1550 nm serial Back Reflection

- Co-authors in support of this proposed change:
- Network Elements Raj Savara
- LightLogic Marc Verdiell
- GTRAN Robert Coenen
- Optovation Scott Bradshaw
- Optillion Fröjdh Krister

1550 nm serial Back Reflection Problem

- Uncooled Unisolated DFB showing the effects of both types of reflective noise
- Graph from LightLogic 9/00

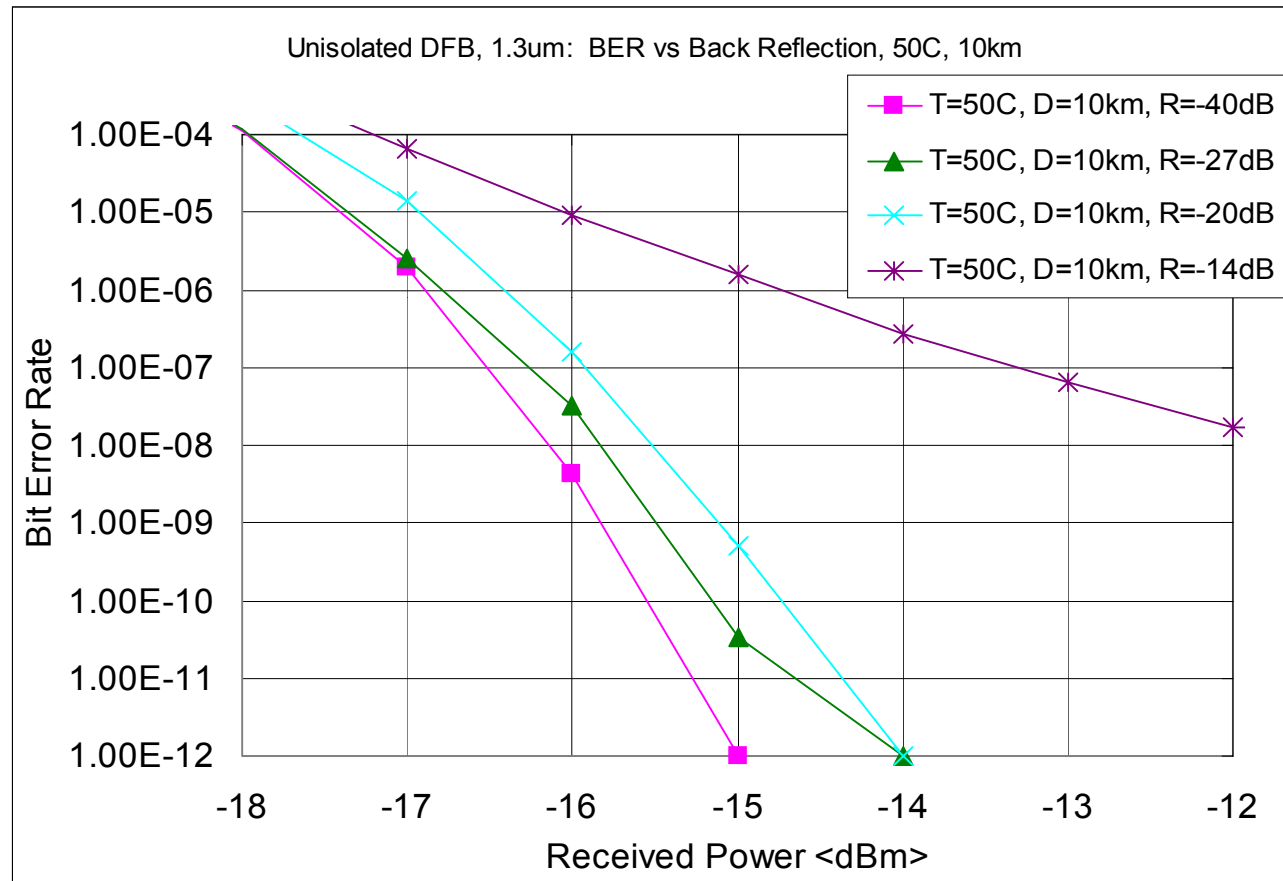
1550 nm serial Back Reflection Objective
